July 25, 2025

PROJECT NAME: HIS HOUSE FOR HER

PROJECT NUMBER: 2025040018

APPLICATION: MAJOR SITE PLAN #32698

L-1

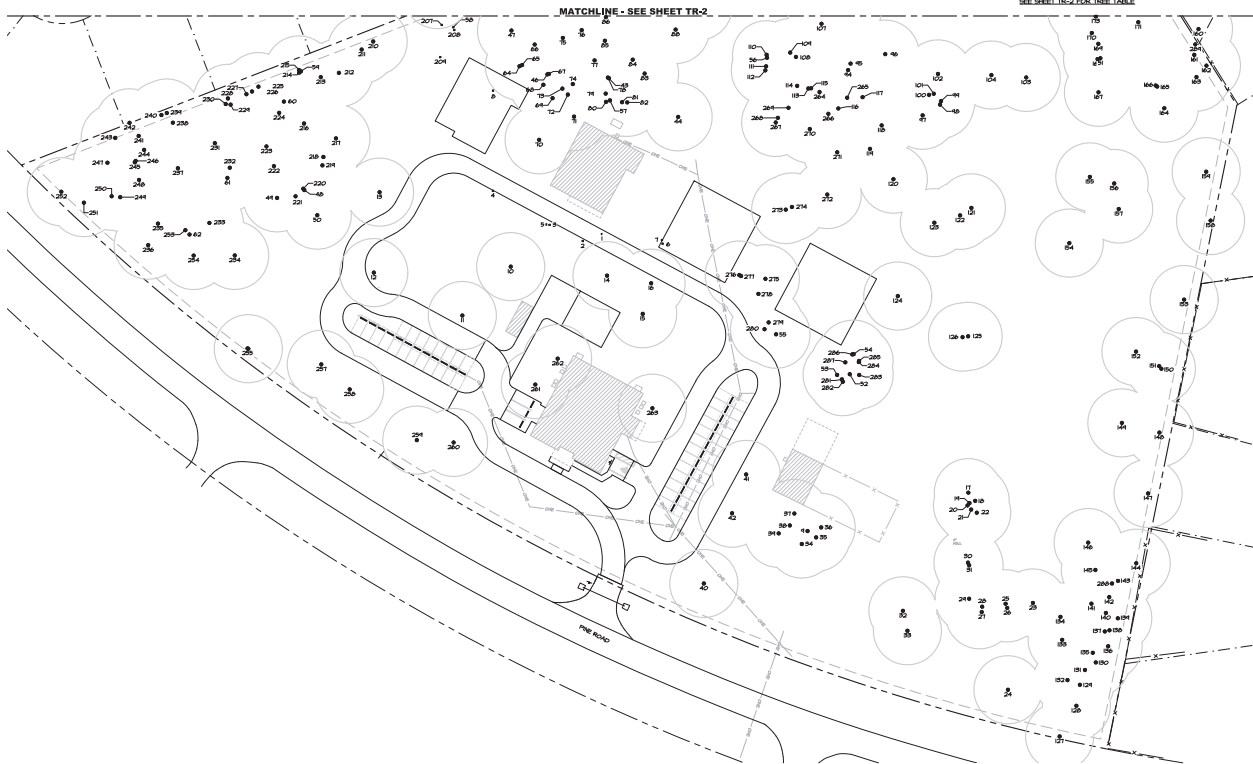
REMARKS: Type C Buffer will be required along Pine Rd. please show on plan

REMARKS: Provide irrigation plan for the buffer along Pine Rd

REMARKS: 7/17 Review: Type C buffer is required by code. Show on the site plan and landscape plan. Any waiver request relating to buffers will be automatically denied during the DRC meeting and sent to the County Commissioners for their consideration.
